Scott Ranch Project

Errata to Final Environmental Impact Report

SCH No. 2004072137

On June 10, 2022, the City of Petaluma released the Final EIR for the Scott Ranch Project. This Errata document provides corrections and clarifications to the information presented in the FEIR. Deleted text is marked in ~~double-strikethrough~~ and new text is marked in double underline:

FIGURE 3.0-6

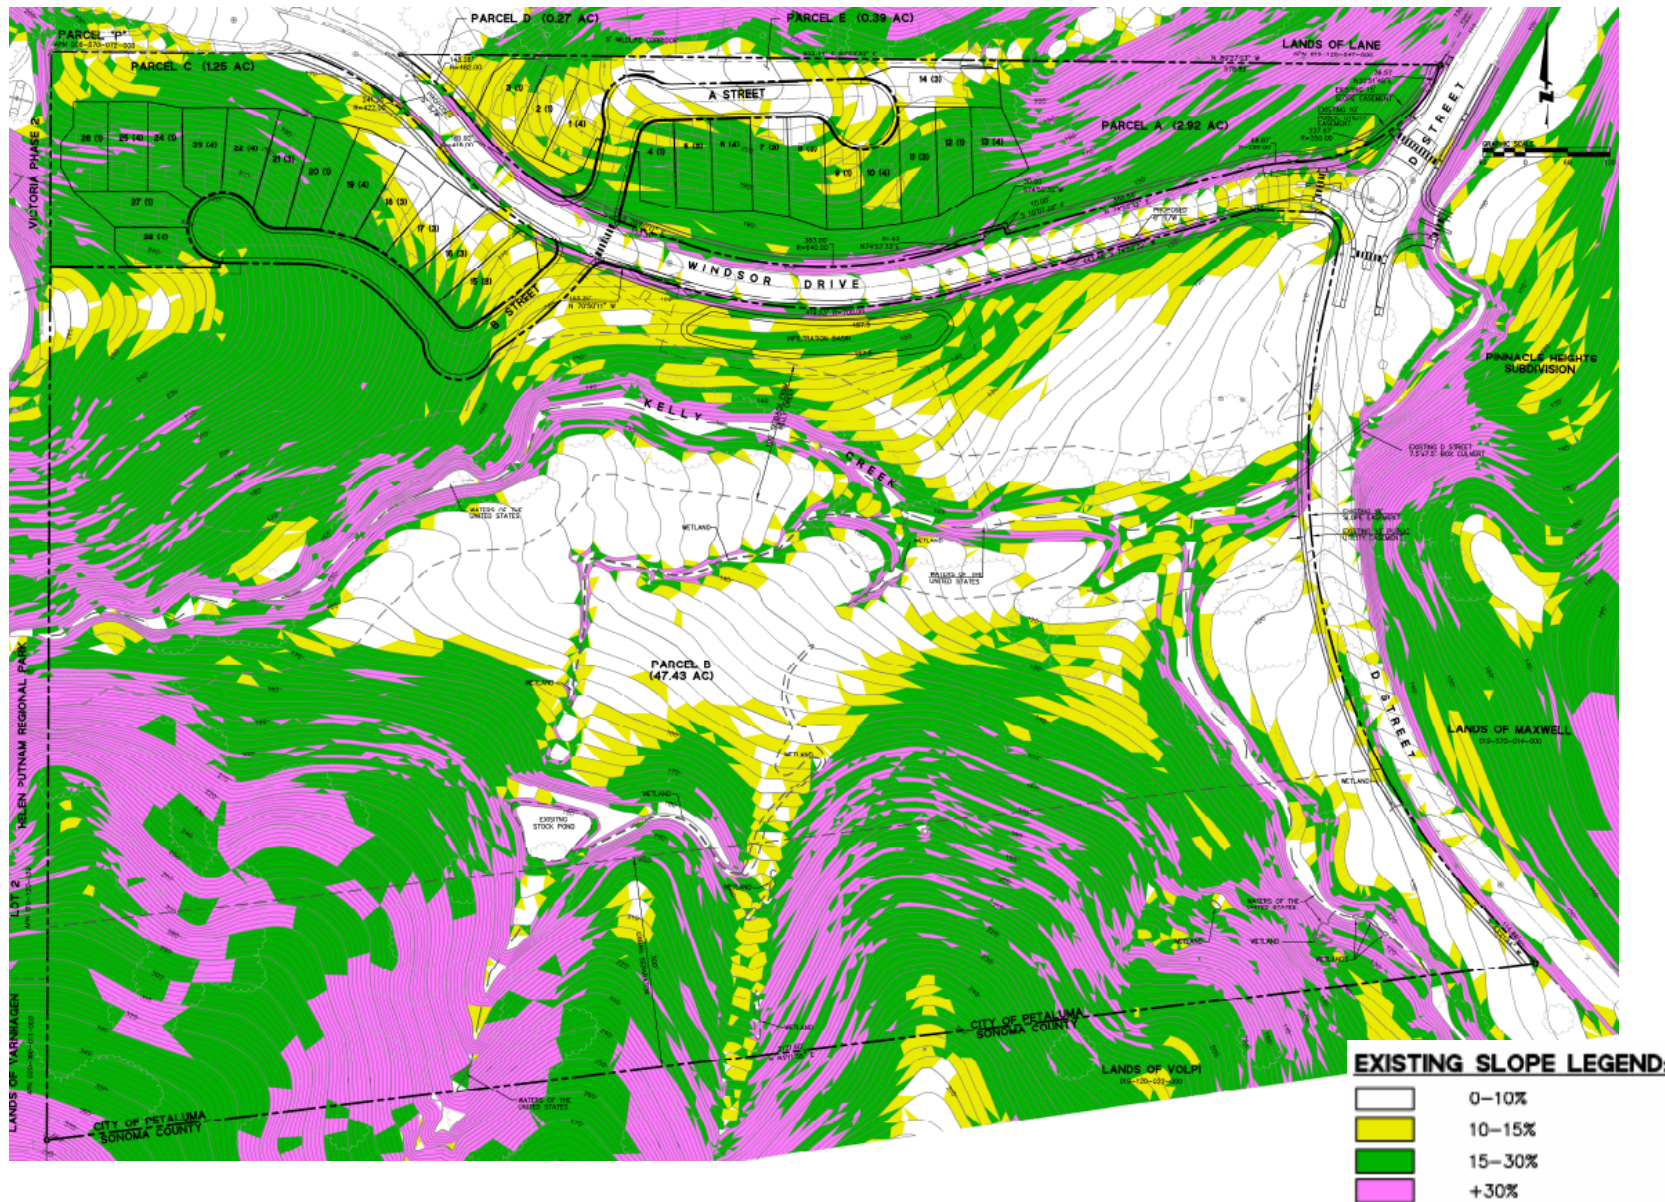
Page 2.0-12, Replace Figure 3.0-6, Project Site Slope

(Replace figure presented in FEIR, with updated Figure 3.0-6, Attached hereto, reflecting the revised site plan.)

FIGURE 3.0-9

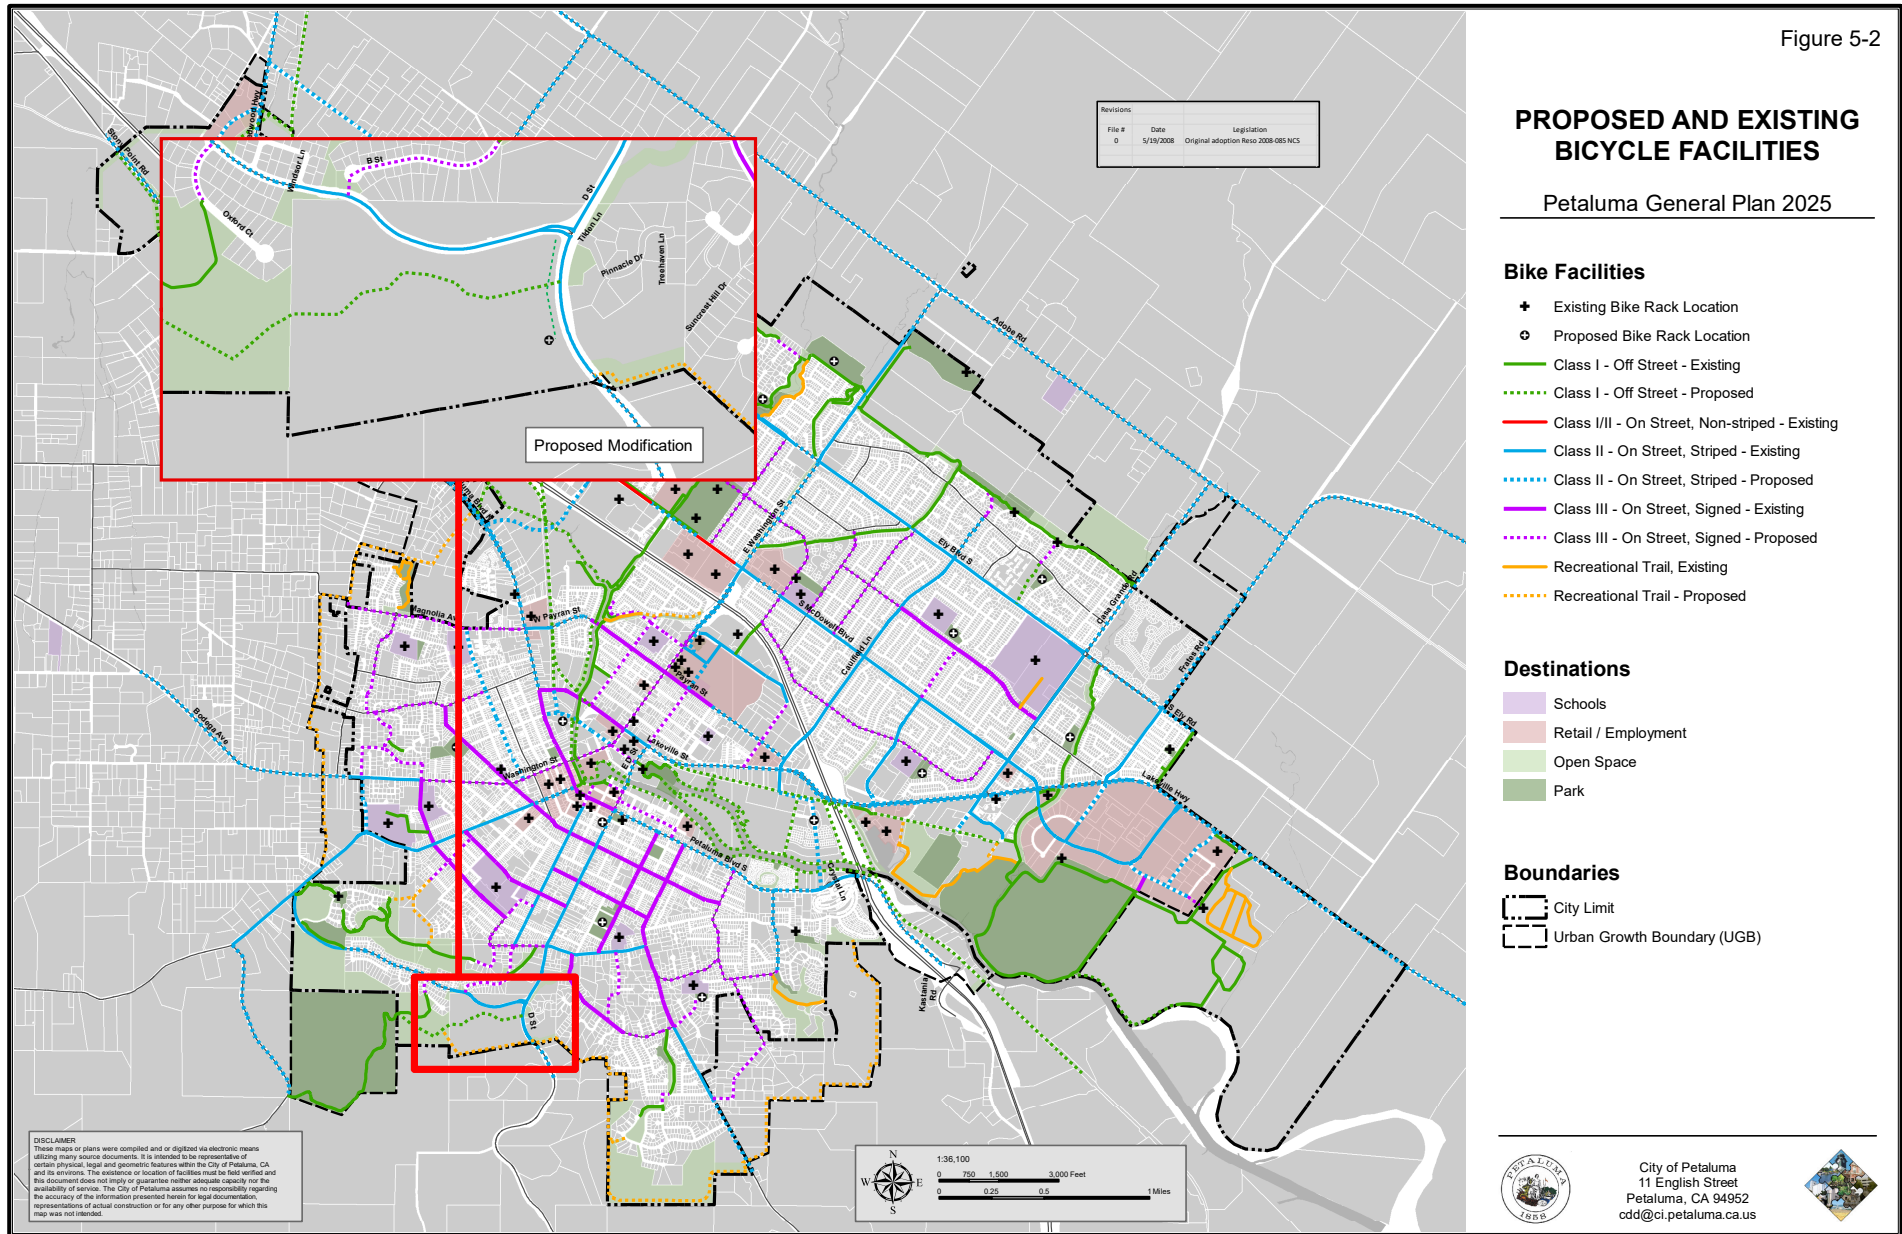
Page 2.0-20, Replace Figure 3.0-9, Proposed Amendments to General Plan Figure 5-2, Bicycle Facilities

(Replace figure presented in FEIR, with updated Figure 3.0-9, Attached hereto, reflecting the Proposed Amendments to General Plan Figure 5-2, Bicycle Facilities.)
